UNITED STATES PATENT AND TRADEMARK OFFICE

APPLICATION NO.	FILING DATE	FIRST NAMED INVENTOR	ATTORNEY DOCKET NO.	CONFIRMATION NO.
10/510,423	04/21/2005	Jaume Prat Terradas	30607/40513	4333

Office Action Summary	Application No. 10/510,423	Applicant(s) TERRADAS ET AL.	
	Examiner Vinh T. Luong	Art Unit 3682

ATTACHMENT 1

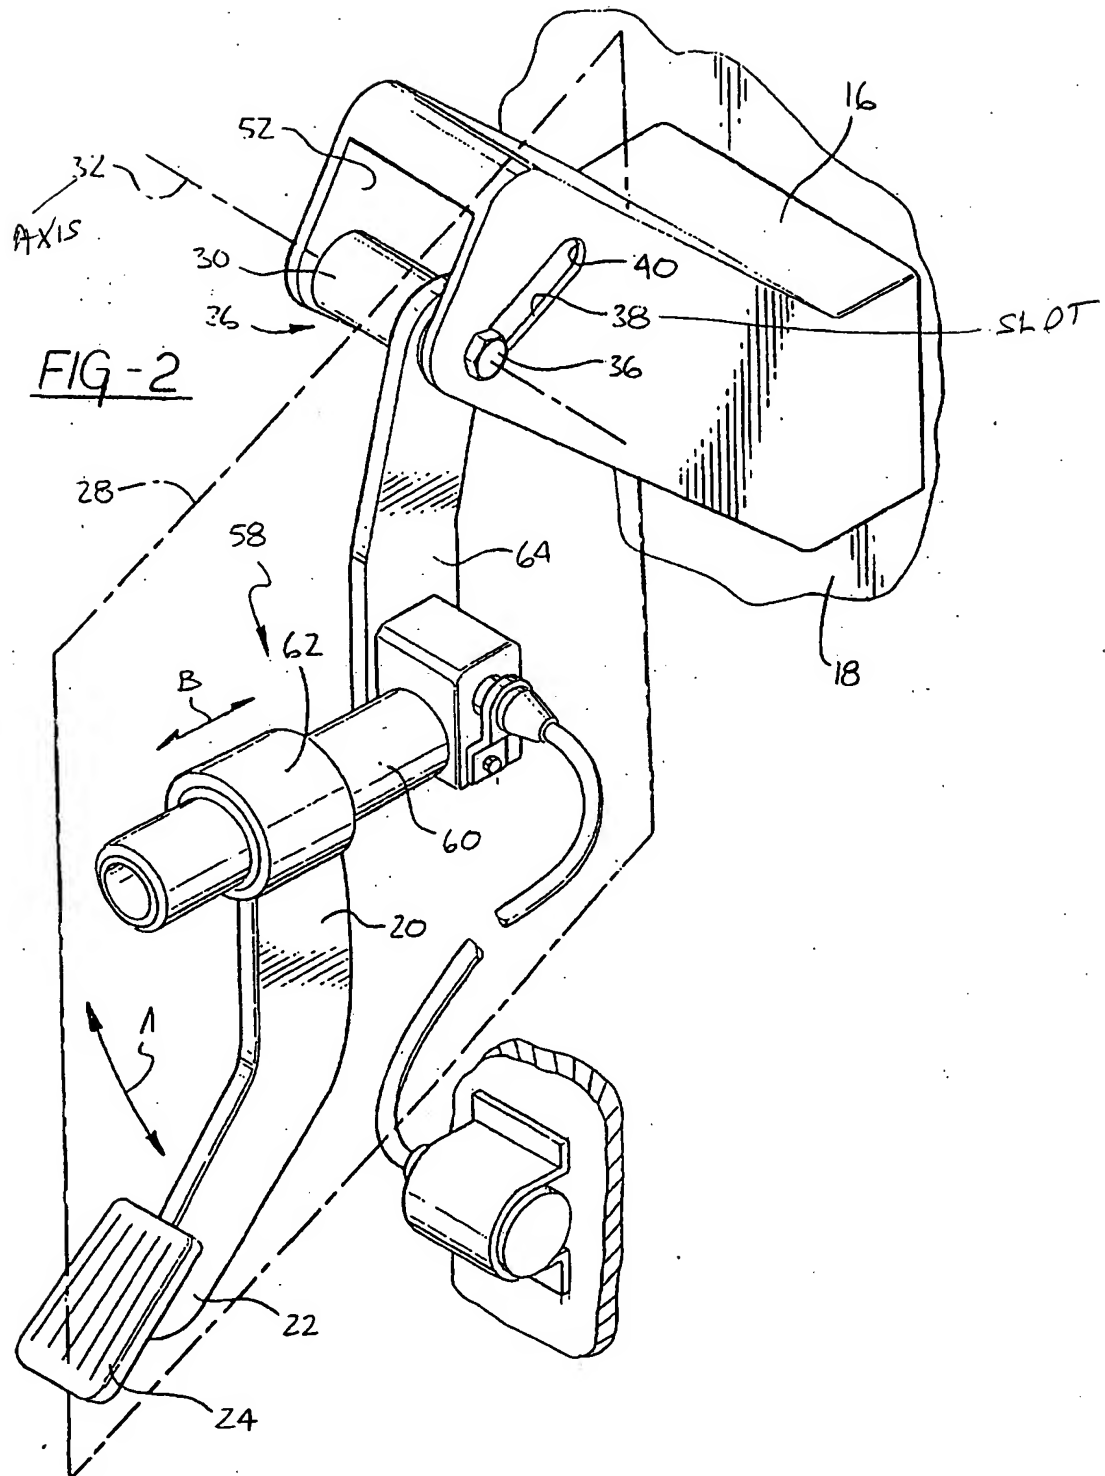
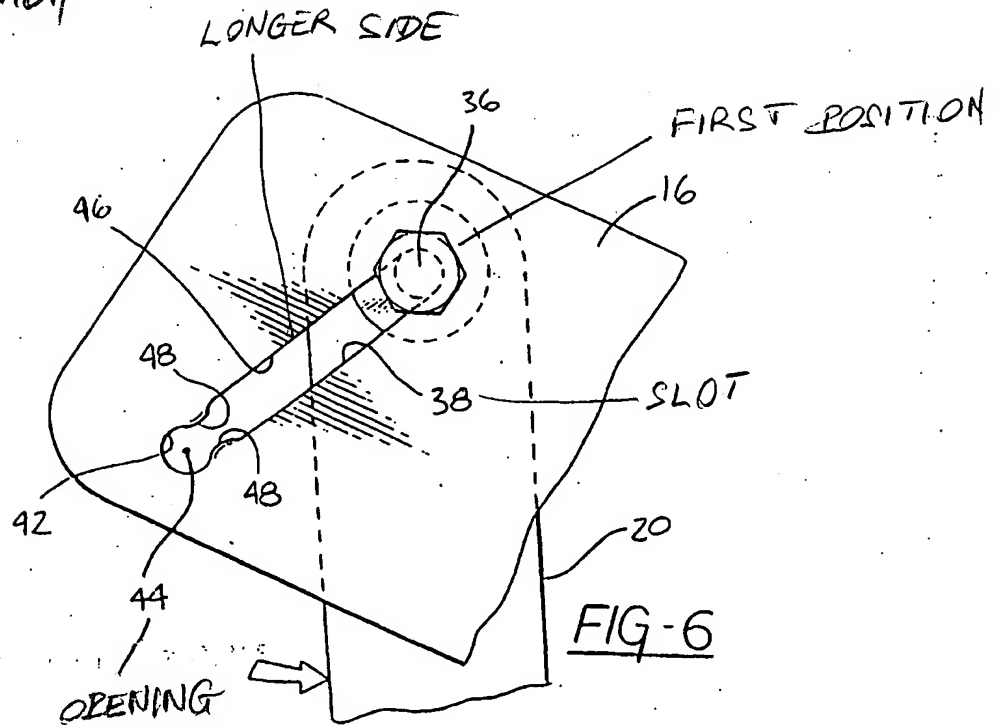
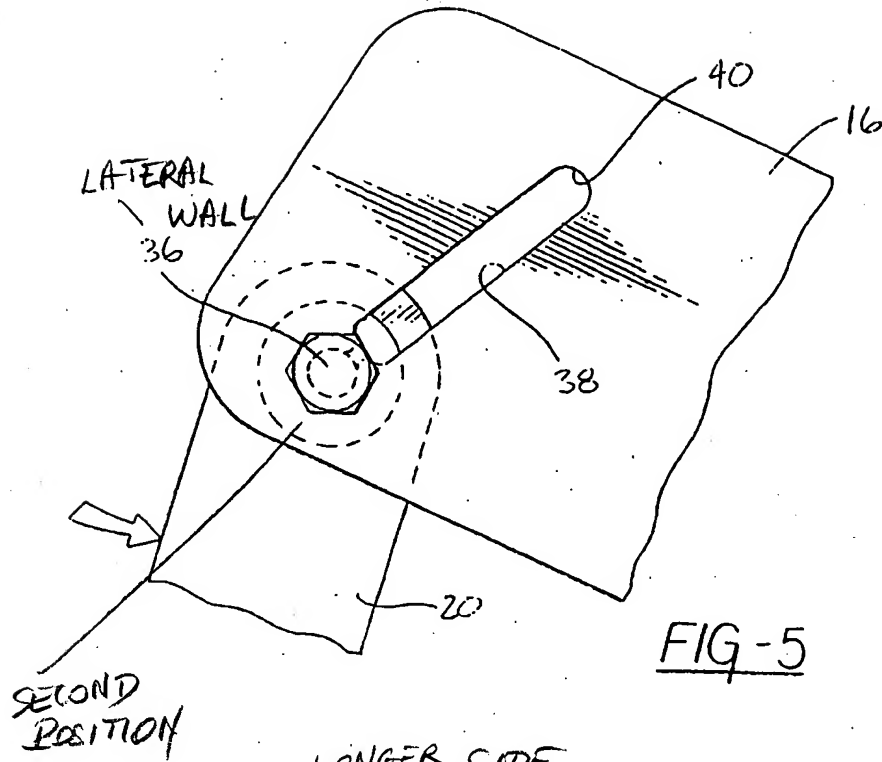
an expandable slot 38 connected to the opening 44 and defining longer sides 46 (*id.* Paragraph [0013], see Attachment 1), the expandable slot 38 comprising movable lateral walls 36 along slot longer sides 46, the movable lateral walls 36 having a first position (FIG. 6) in which the lateral walls 36 project into the expandable slot 38 and a second position (FIG. 5) in which the lateral walls 36 are moved out of the expandable slot 38, wherein the pedal axis 32 engages the movable lateral walls 36 and moves the lateral walls 36 from the first position (FIG. 6) to the second position (FIG. 5) by exceeding a mechanical limit loading of the pedal axis 32, whereby the expandable slot 38 receives the pedal axis 32. *Ibid.* claims 1-19.

Regarding claim 9, a pushing element 64 cooperates with the pedal axis 32 to transmit a load to the pedal axis 32, thereby forcing the pedal axis 32 into the expandable slot 38 when the load exceeds the mechanical limit loading of the pedal axis 32.

Regarding claim 11, the expandable slot 38 is formed by an elongated hole (FIGS. 2-6) which is partly closed by the moveable lateral walls 36 projecting therein.

ATTACHMENT 2

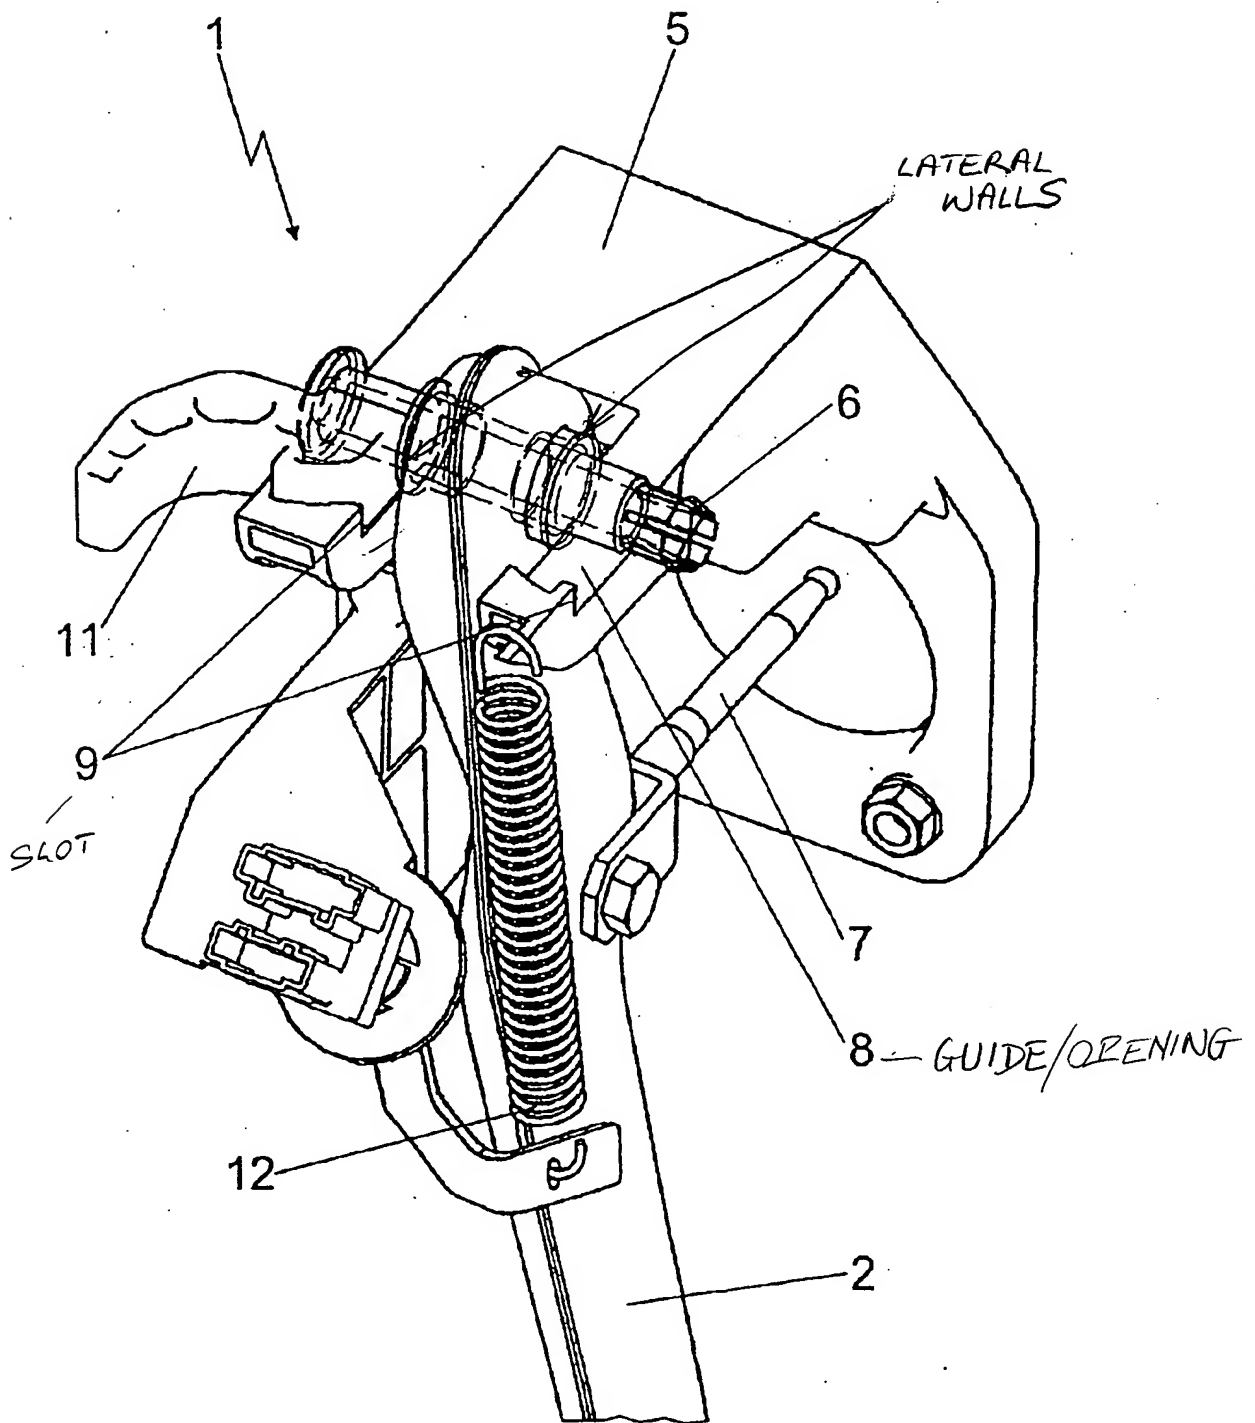
an expandable slot 9 connected to the opening 8 and defining longer sides 9, the expandable slot 9 comprising movable lateral walls (unnumbered, see Attachment 2 hereinafter "Att. 2") along slot longer sides 9, the movable lateral walls (Att. 2) having a first position in which the lateral walls (Att. 2) project into the expandable slot 9 and a second position in which the lateral walls (Att. 2) are moved out of the expandable slot 9, wherein the pedal axis 6 engages the movable lateral walls (Att. 2) and moves the lateral walls (Att. 2) from the first position to the second position by exceeding a mechanical limit loading of the pedal axis 6, whereby the expandable slot 9 receives the pedal axis 6. *Ibid.* Claims 1-16.

Regarding claim 11, the expandable slot 9 is formed by an elongated hole (FIGS. 1-5), which is partly closed by the moveable lateral walls (Att. 2) projecting therein.

Regarding claim 12, the moveable lateral walls (Att. 2) are bent, dismounted, or pushed away from the expandable slot 9 in response to the mechanical limit loading by the pedal axis 6.

Regarding claim 13, a spring 12 is coupled operatively to the lateral walls (Att. 2), wherein the moveable lateral walls (Att. 2) are pushed by said pedal axis 6 against the load of the spring 12.
